Model: PRIPORT TITANIUM				'-Apr-03	No: R-C252-001	
Subject: Notes the model TT installation			Prepared by:			
				M. Ohtsubo, Priport Service Planning Section		
Classification:	Troubleshooting	☐ Part information ☐ Action required		required		
	☐ Mechanical	☐ Electrical		⊠ Service manual revision		
	☐ Paper path	☐ Transmit/receive		☐ Retrofit	information	
	Other ()					
Model Name:						
Ricoh JP730/JP750 RexRotary 6123cp	/JP780C, Gestetner 6123lcp/54	410c/6123cp, Lani	er LDD 7	30, nashuat	ес 6123ср,

Technical Bulletin

Model: PRIPORT TITANIUM			Date: 23-Oct-	-03	No: R-C252- 003	
Subject: Notes for model TT installation - revision		Prepared by:				
		M. Ohtsubo, Priport Service Planning Section				
Classification:	Troubleshooting	☐ Part informati	on 🗌 Ad	ction r	tion required	
	☐ Mechanical	☐ Electrical	Service r Service		manual revision	
	☐ Paper path	☐ Transmit/rece	eive 🗌 Retrofi		information	
	Other ()					
Model Name:						
Ricoh JP730/JP750 RexRotary 6123cp	/JP780C, Gestetner 6123lcp/54	410c/6123cp, Lani	er LDD 730, nas	shuate	ес 6123ср,

Model: PRIPORT TITANIUM			Date: 9-Mar-05		No: R-C252- 004	
Subject: Black line on the copy print			Prepared by:			
			M. Ohtsubo, Priport S

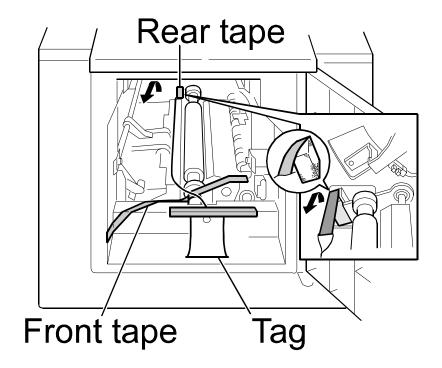
As announced in RTB #RC252-001, a Styrene foam sponge is used to ensure that the rear shipping tape stays properly fixed in place, which prevents the printing pressure release lever from unlocking. At installation, please remove the rear tape by pulling the portion shown in the photo below toward the front of the machine.

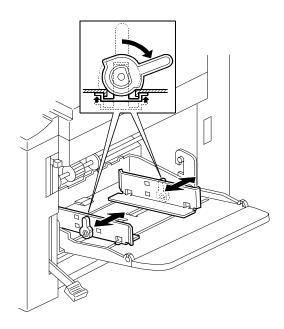
The left or/and right edges of the original can be seen on the printout as black lines.

1. The paper tray side fences are not aligned with the scanner unit side fences.

2. The original is smaller than the printing paper.

- 1. Measure the distance from the paper edge to the black line (X mm).
- 2. Move the side fences a distance of about X mm, so that the edge of the paper aligns with the edge of the original.
- 3. Check the print results. Repeat this until you cannot see the black line on the printout.

- 1. Decrease the image density setting, or
- 2. Increase the magnification setting so that the original size matches the print paper size.
